**ALAMEDA POINT
MASTER INFRASTRUCTURE PLAN
ADDENDUM SHEET**

The Final Master Infrastructure Plan (MIP) for Alameda Point will incorporate the following addendums to the Updated Draft MIP, dated October 31, 2013.

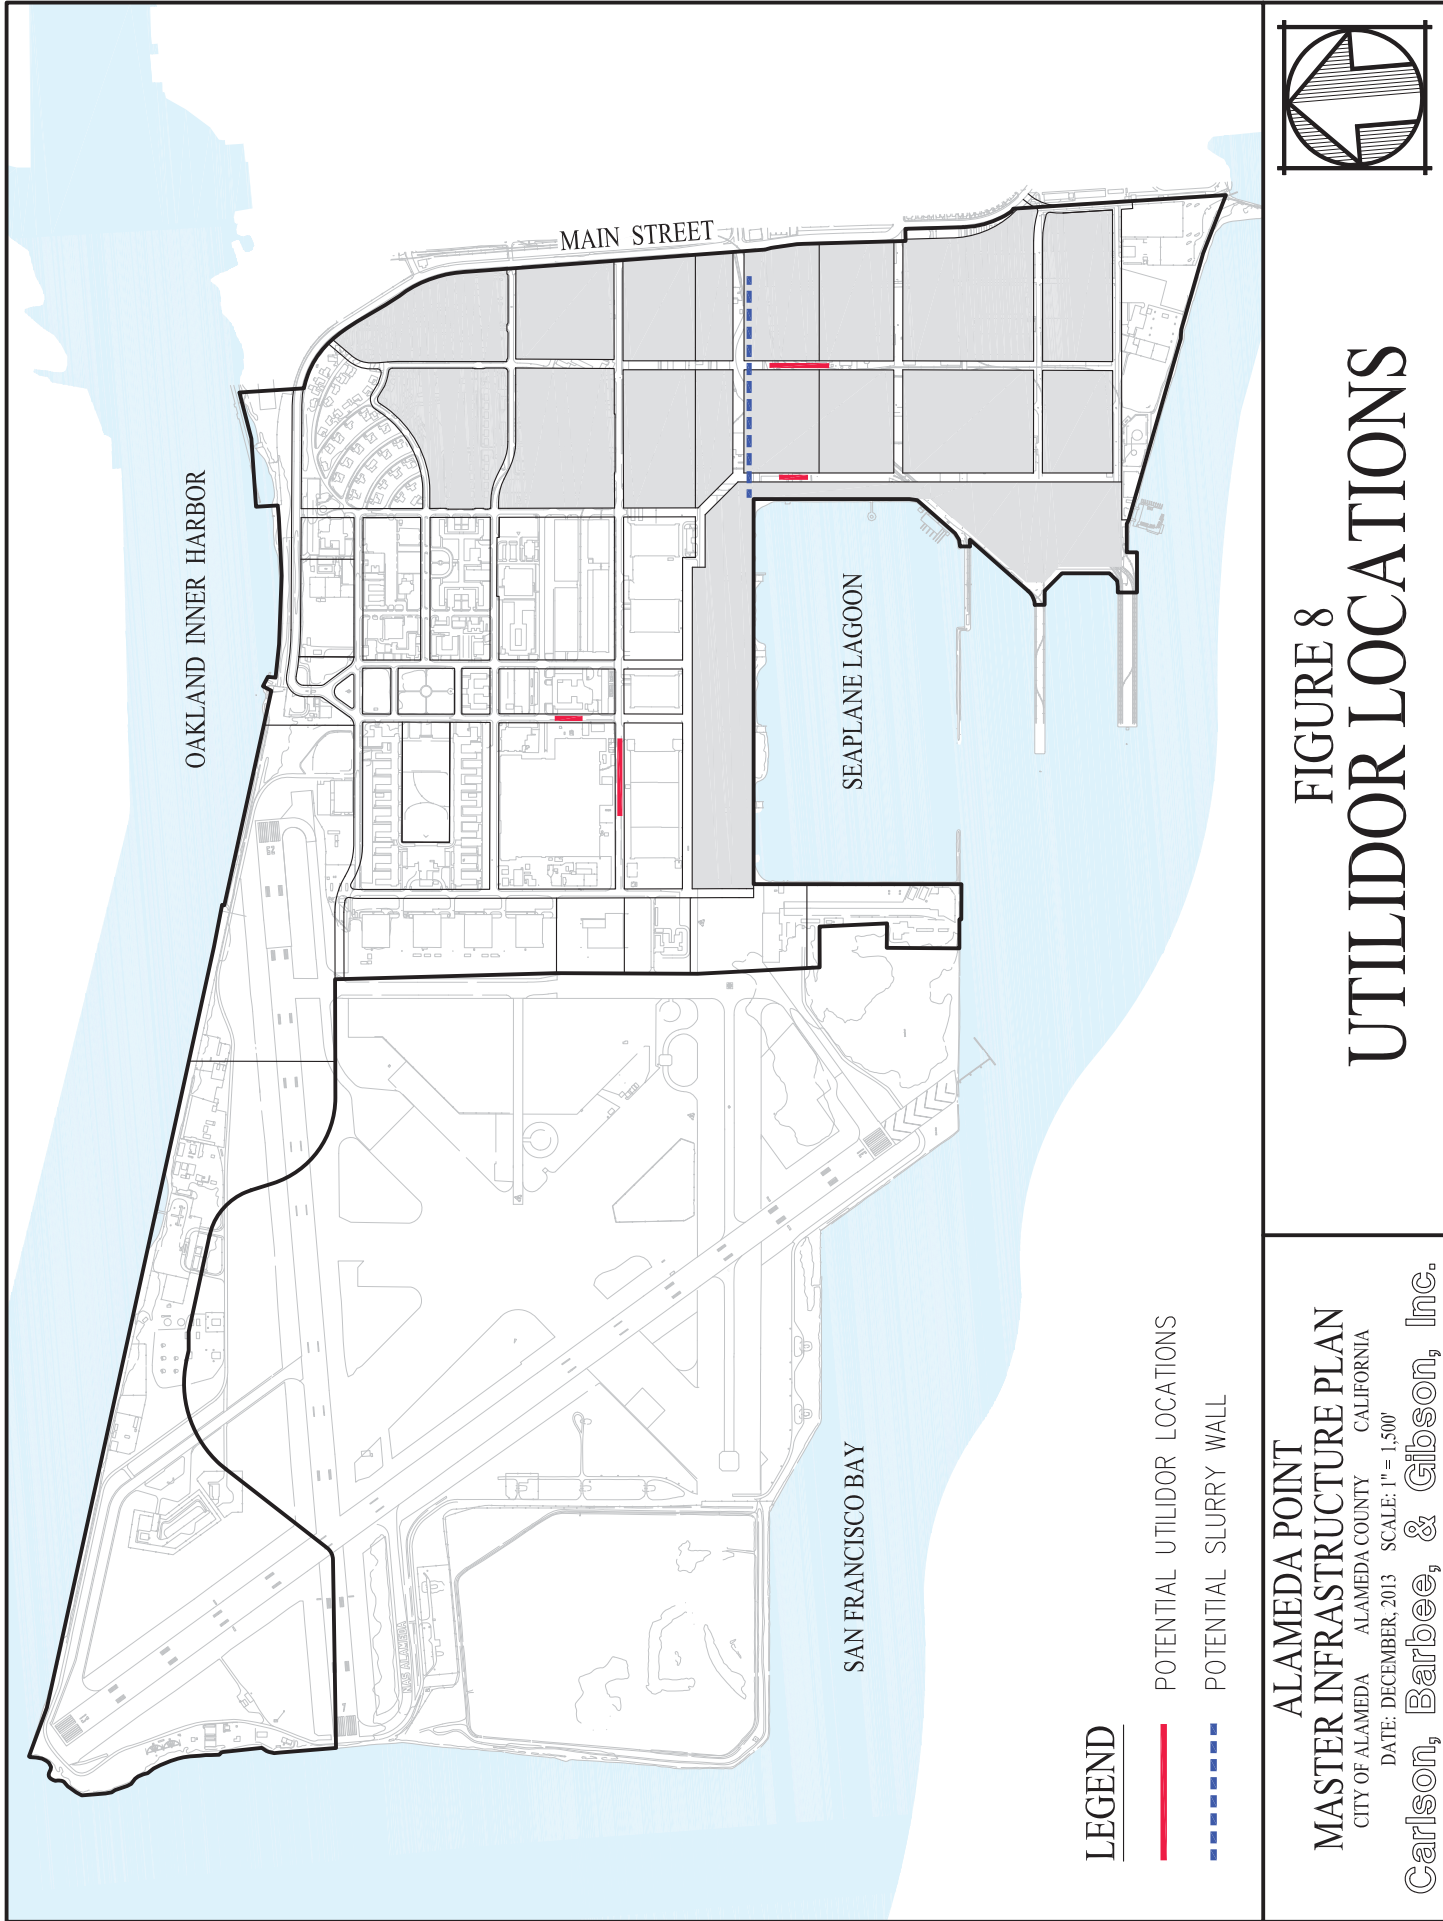
Revise Figure 8 to depict the updated locations of utilidors and slurry walls based on the most recent information available regarding the Navy's remediation efforts. (See attachment)

FIGURE 11 FLOOD PROTECTION 24" SEA LEVEL RISE

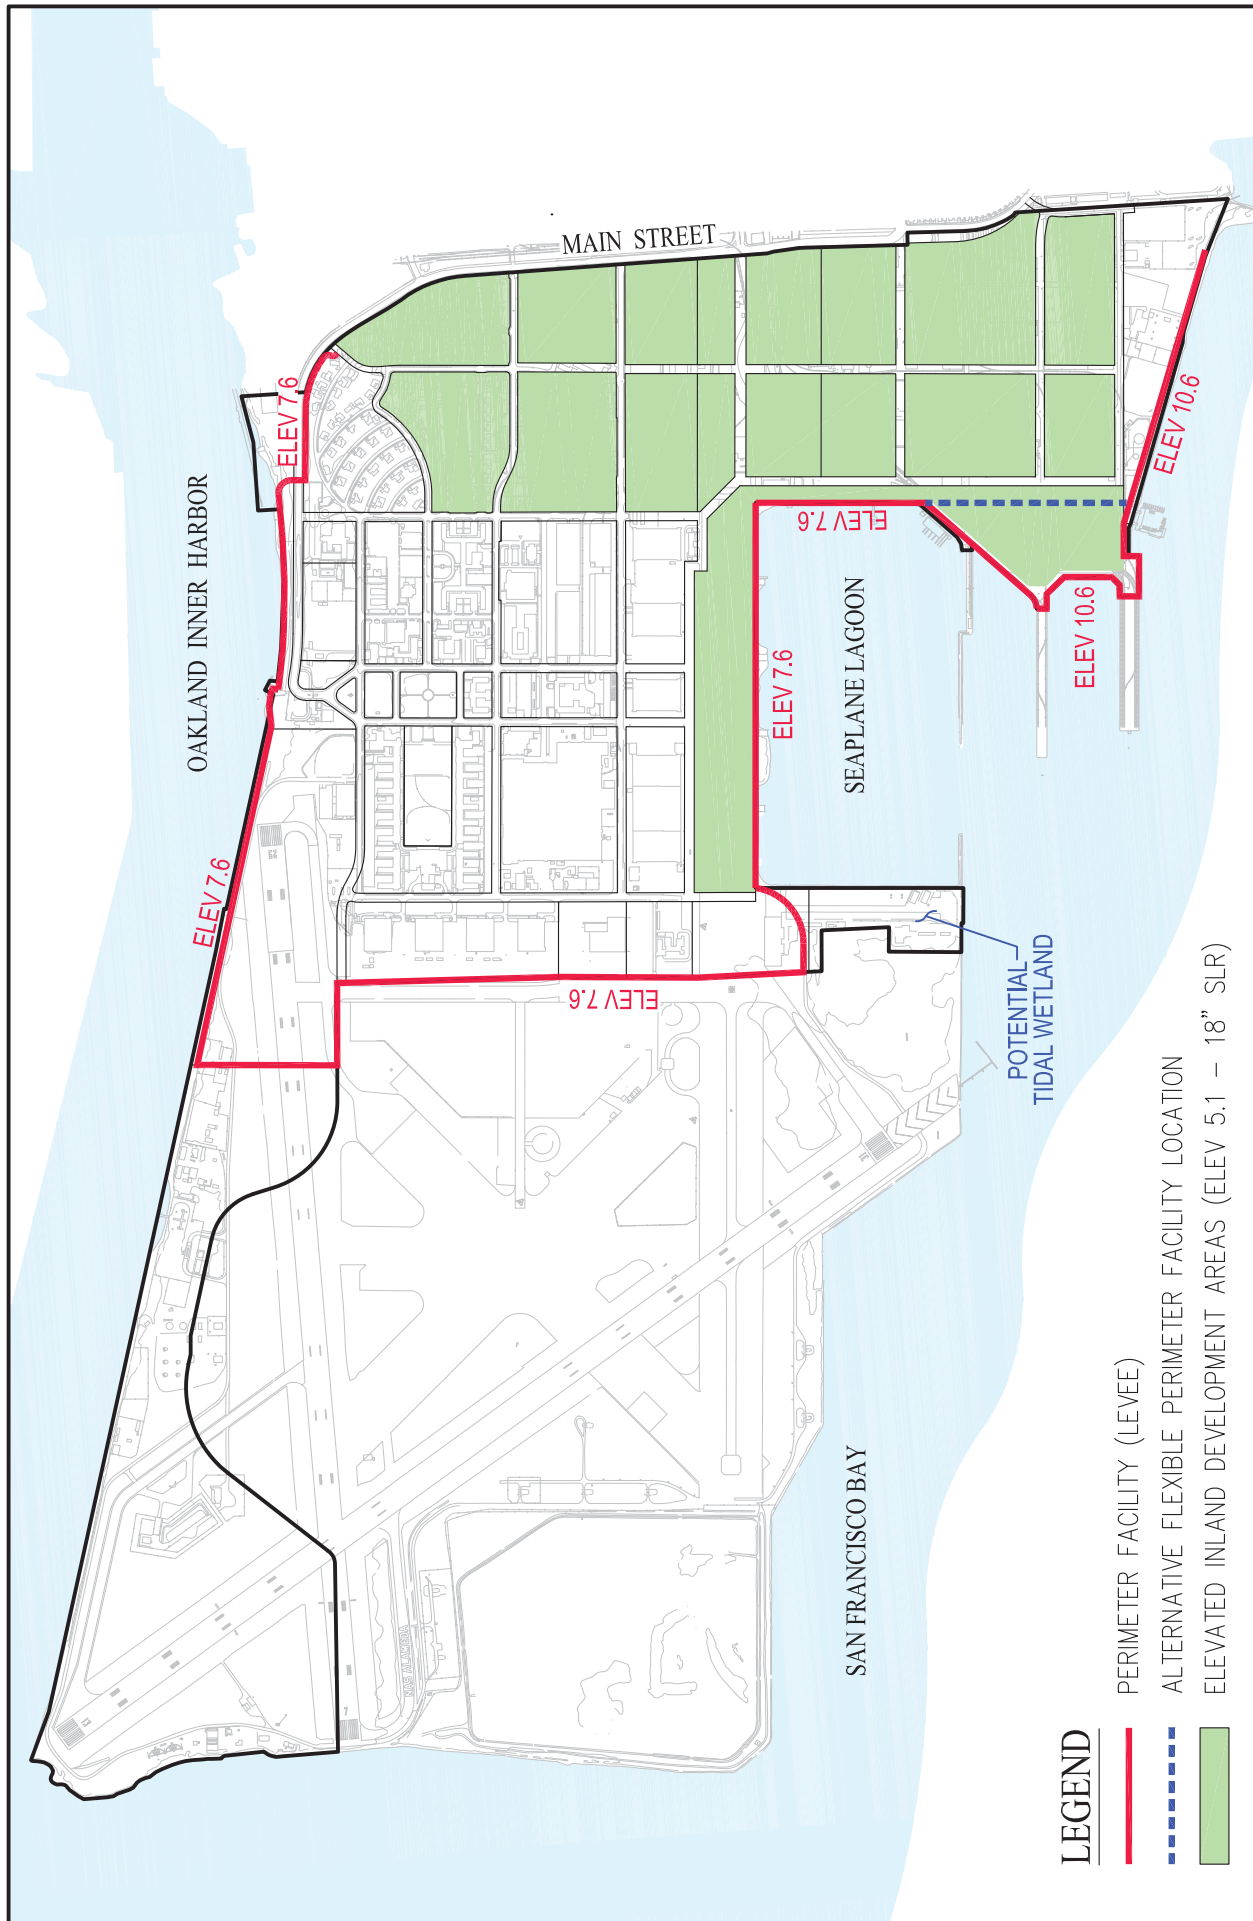
Revise Figures 11, 13 and 14 to depict updated initial flood protection system. (See attachment)

FIGURE 23
WEST ATLANTIC AVENUE
DEVELOPMENT AREAS

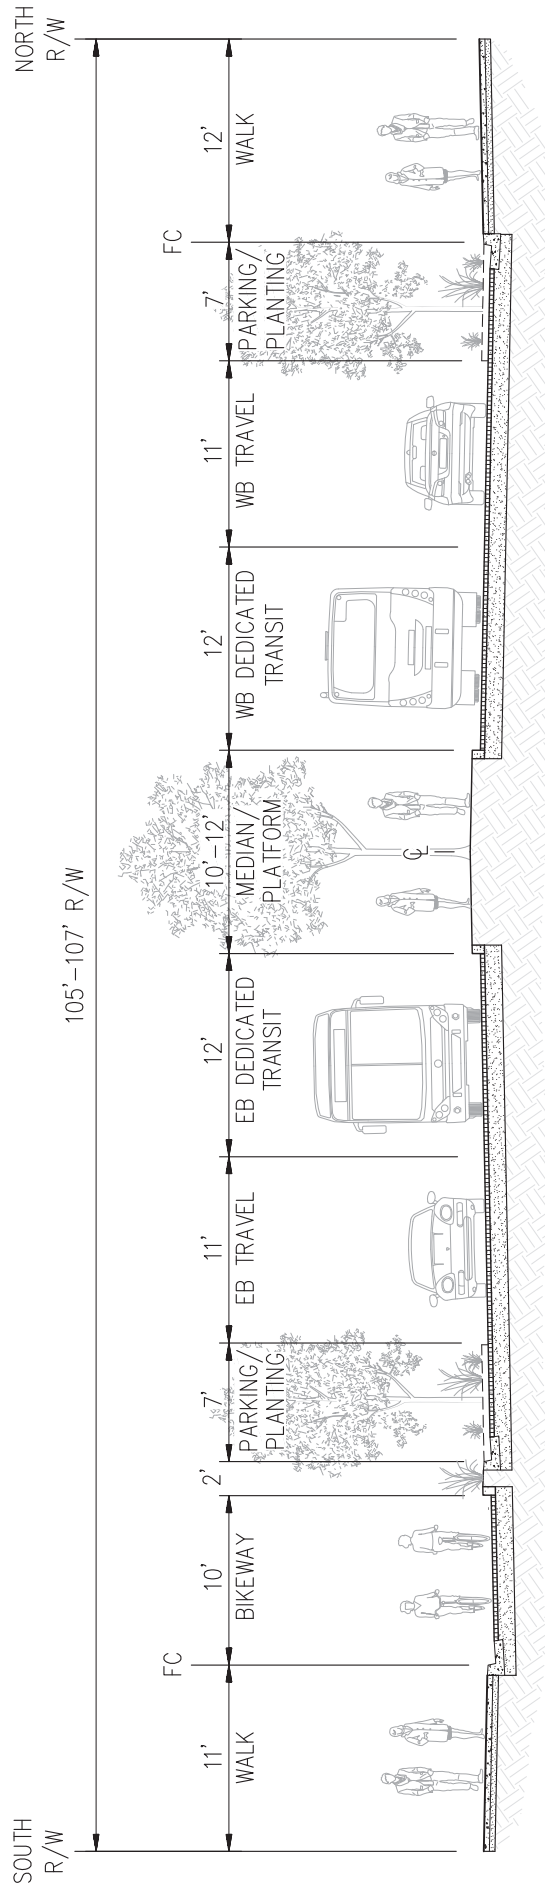
Revise Figure 23, West Atlantic Avenue to reflect the current concepts from the Town Center and Waterfront Precise Plan, which will ultimately be finalized in the final Precise Plan document. (See attachment)

FIGURE 24
WEST REDLINE AVENUE EXTENSION
REUSE AREAS

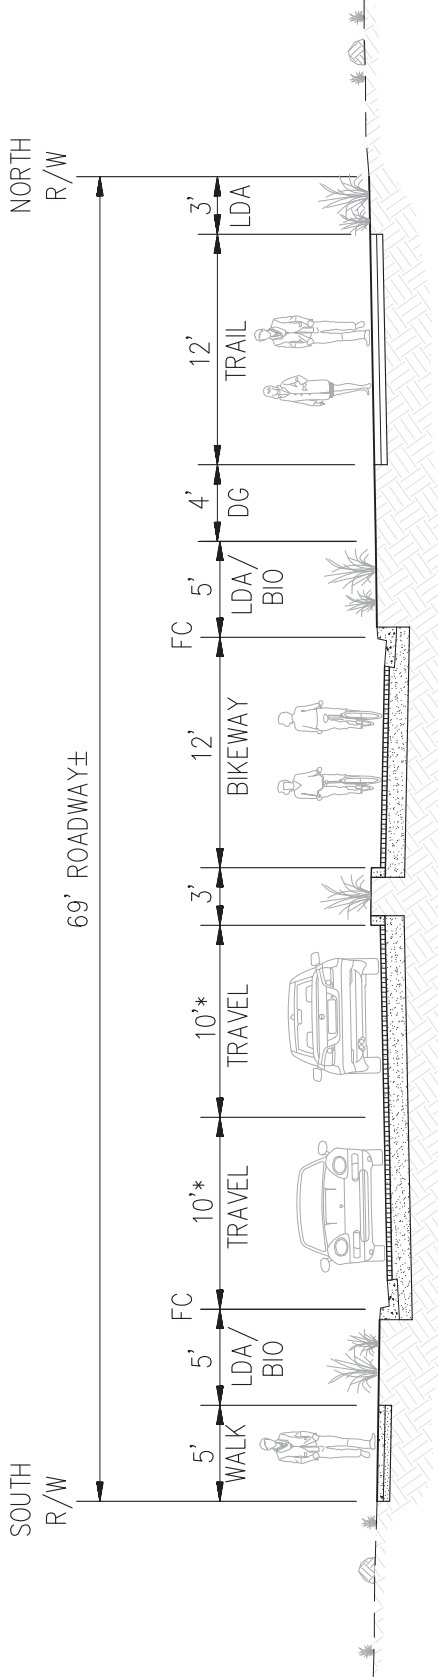
Add Figure 23, West Redline Extension. (See attachment)

FIGURE 28.1
CENTRAL AVENUE
 CONCEPTUAL ALIGNMENT

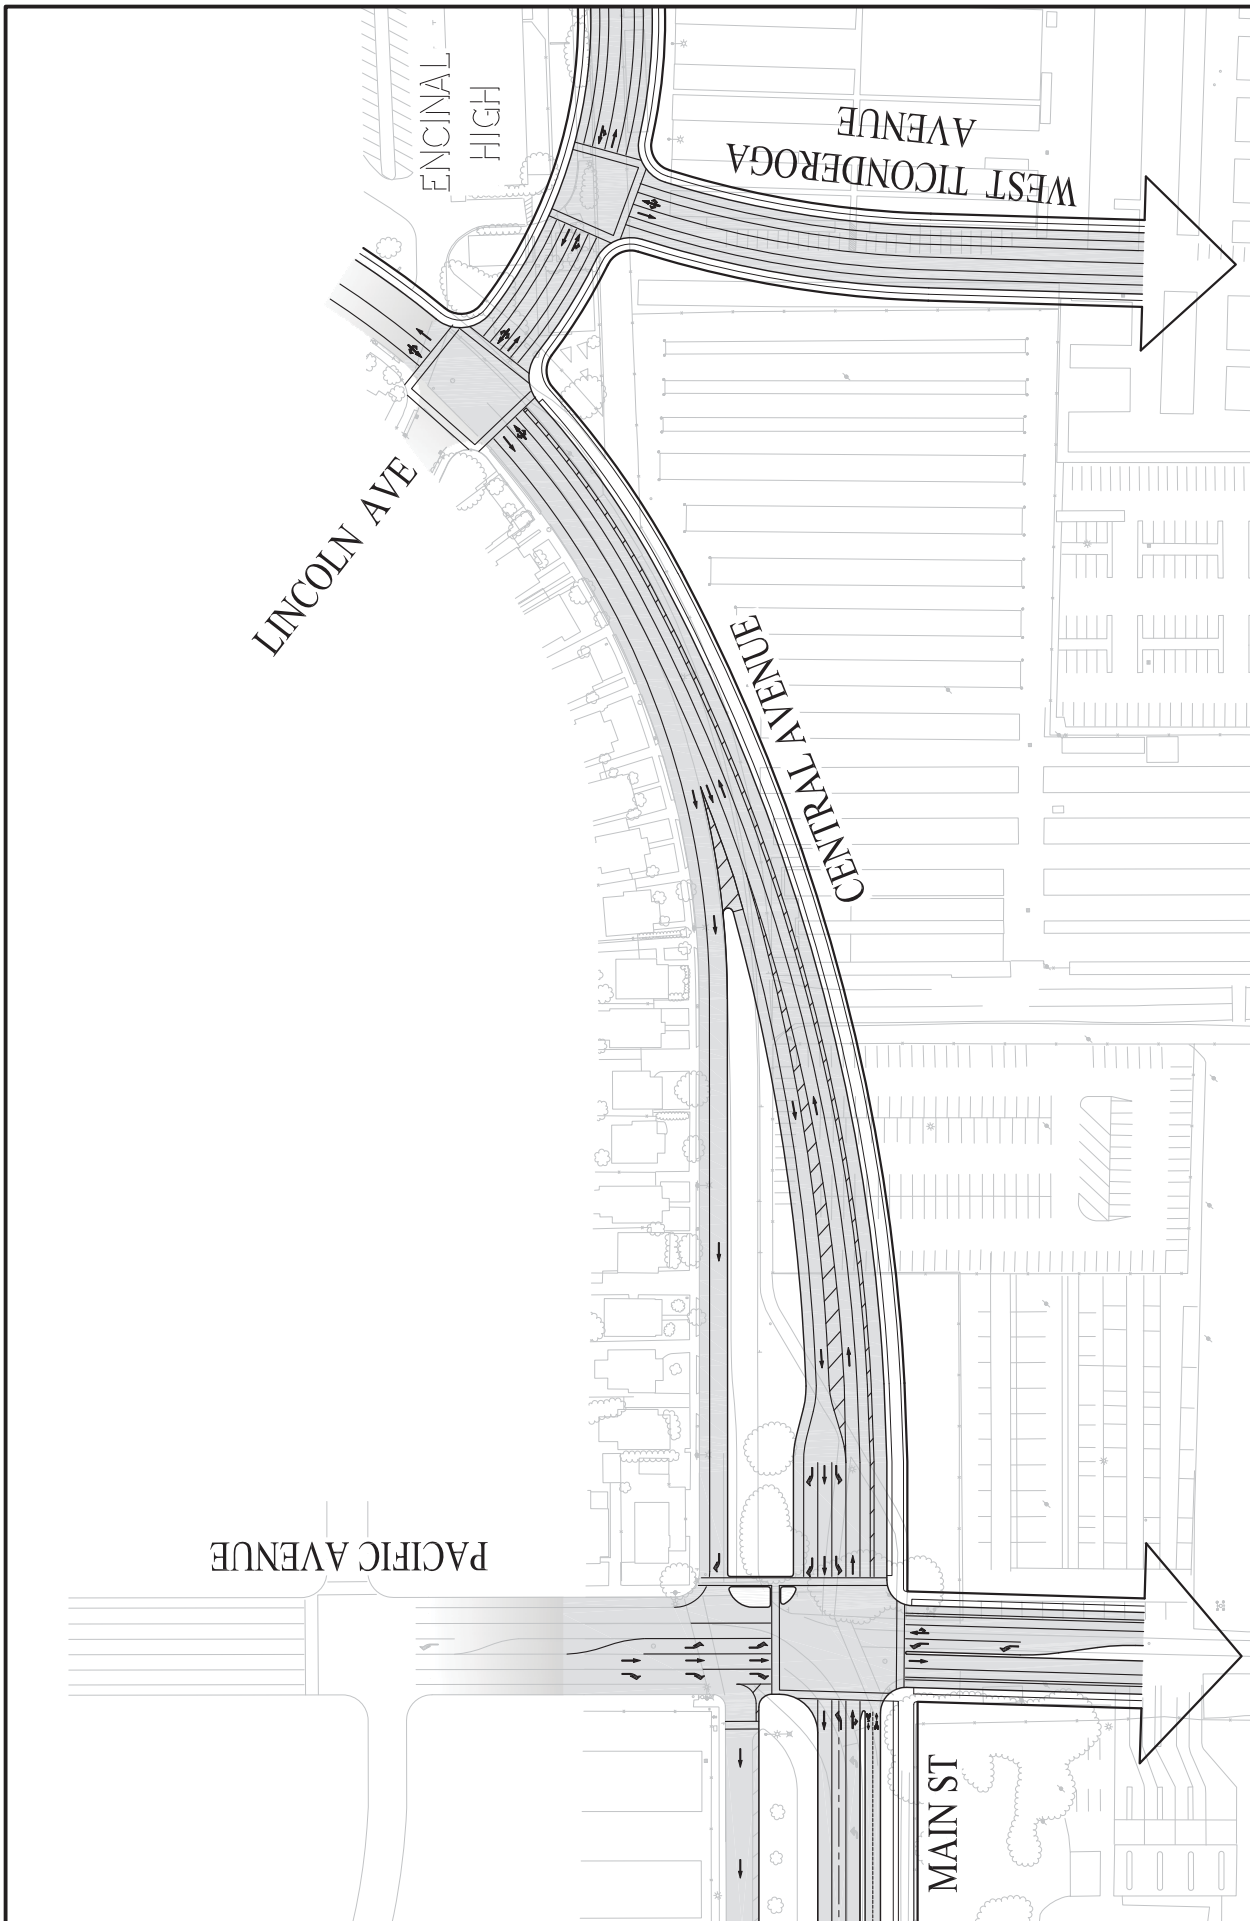
Add Figure 28.1, Central Avenue Concept. (See attachment)
